JOINT PLANNING COMMITTEE
UPDATE SHEET – 14 November 2018

WA/2017/2391

LAND SOUTH OF HIGH STREET BETWEEN ALFOLD ROAD AND KNOWLE LANE, CRANLEIGH

The submitted plan which is referred to on page 33 is drawing number: EXA_1635_PH2.2_300 Rev C entitled 'Laps & Leaps'. This plan shows the following:

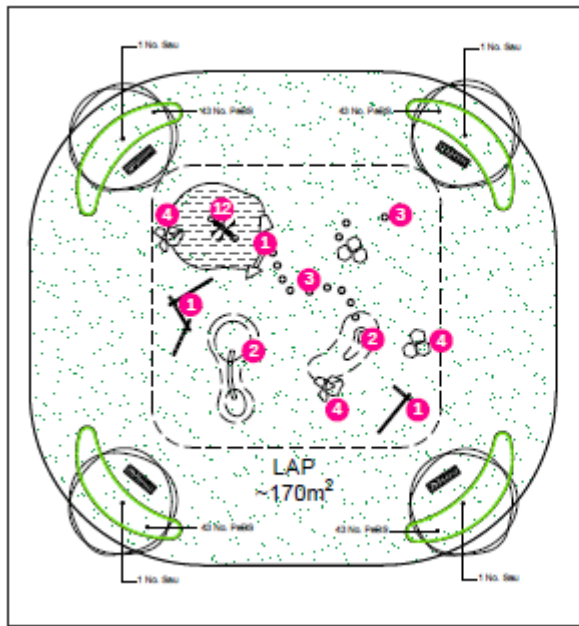
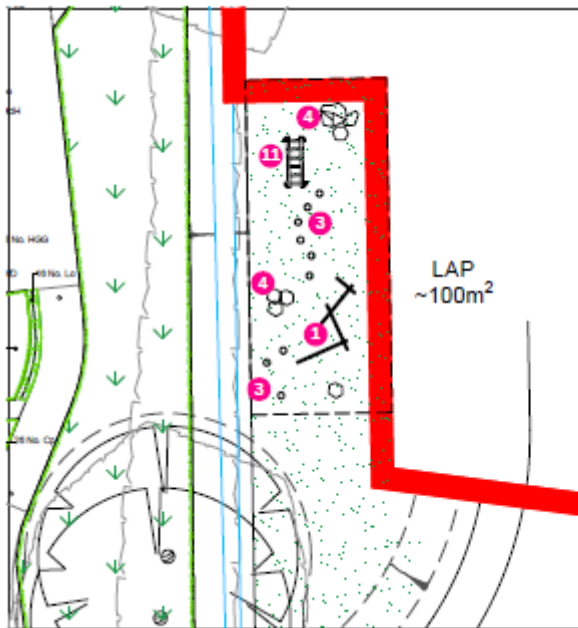
Officers have consulted with the Council’s Parks Project and Playspace Officer, who recommended some changes to the type of equipment and surfacing underneath the equipment. These changes have all been incorporated and, following review of the submitted information, the Council’s Parks Project and Playspace Officer considers the specification to be acceptable.

On this basis, Officers have recommended (Recommendation B) that the details pursuant to Schedule 4, Clause 1.1.1 of the Section 106 Agreement be approved.
